BDCP Operations Modeling Review

January 17, 2014

- Purpose of this study
- Review of BDCP EIR/EIS operations modeling
- Changes in the projected effects of the BDCP revealed by independent operations modeling
- Conclusions
- Recommendations

Incorporation of Climate Change

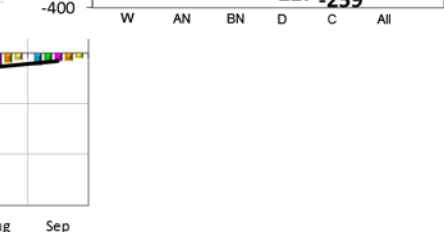
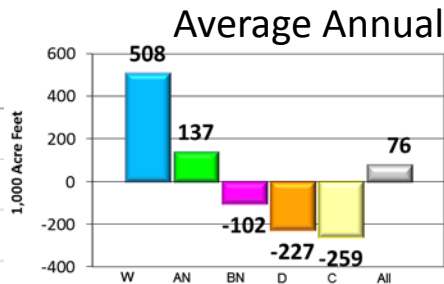
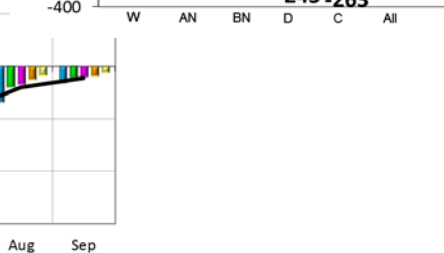
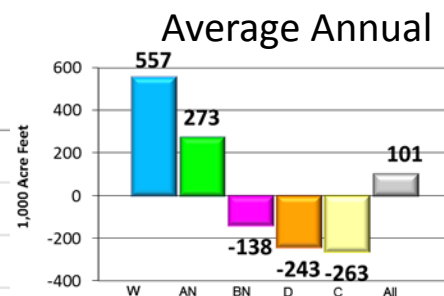
Existing standards and CVP/SWP operating criteria are not designed for climate change effects of this magnitude

- Annual dry and critical year decrease in CVP/SWP reservoir inflows of ¼ MAF
- Seasonal shifts of ½ MAF

Climate change was incorporated into model without reasonable adaptation measures producing unrealistic CVP/SWP operations

Annual Change in Delta Diversions

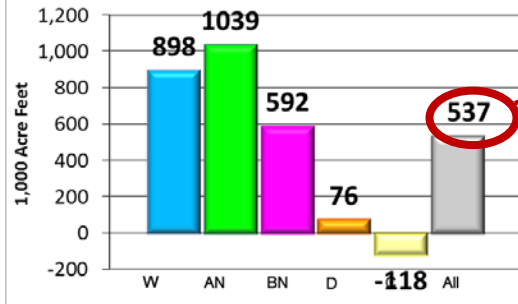
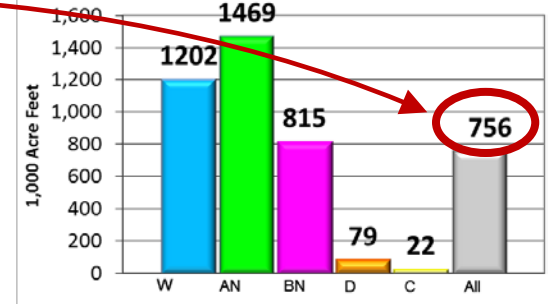
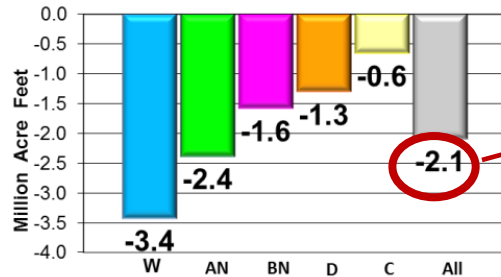
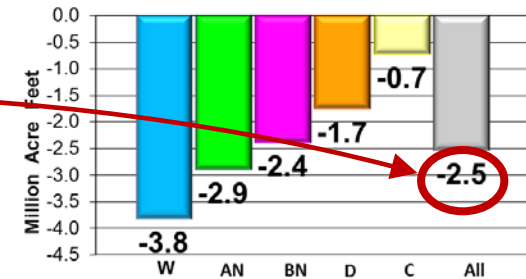
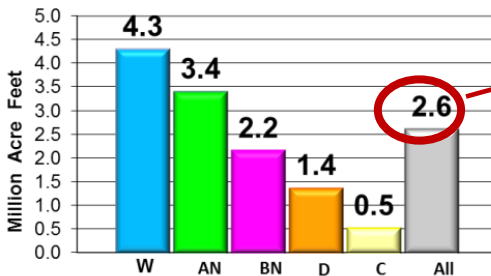
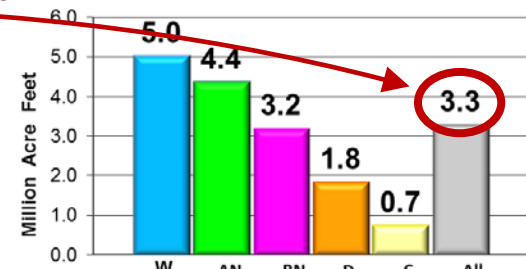
Total Exports
200 TAF increase

Through Delta
466 TAF decrease

686 TAF increase

Change in Delta Outflow

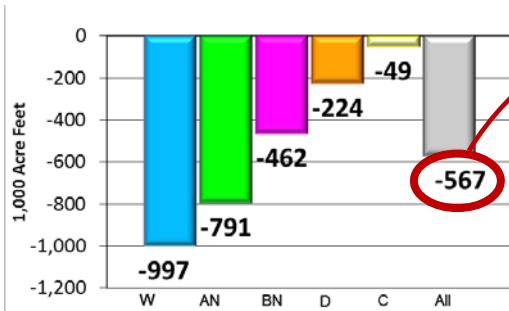
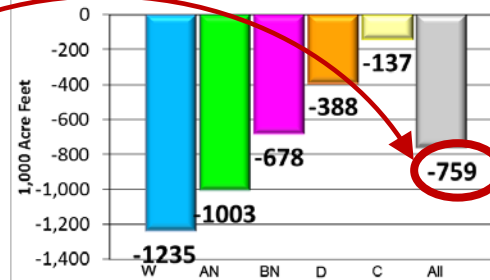
Annual Average
About 200 TAF Decrease

October difference in Sacramento
River Flow to Central Delta

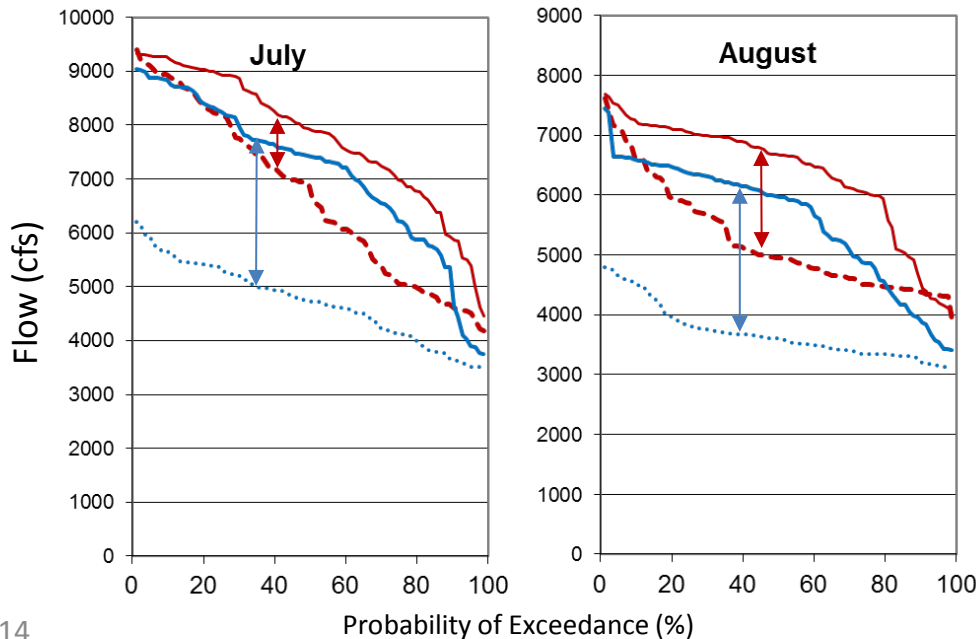
Independent modeling shows
larger decrease in flow entering
central Delta due to gate closure
and higher NDD with lower
Sacramento River inflow to the
Delta
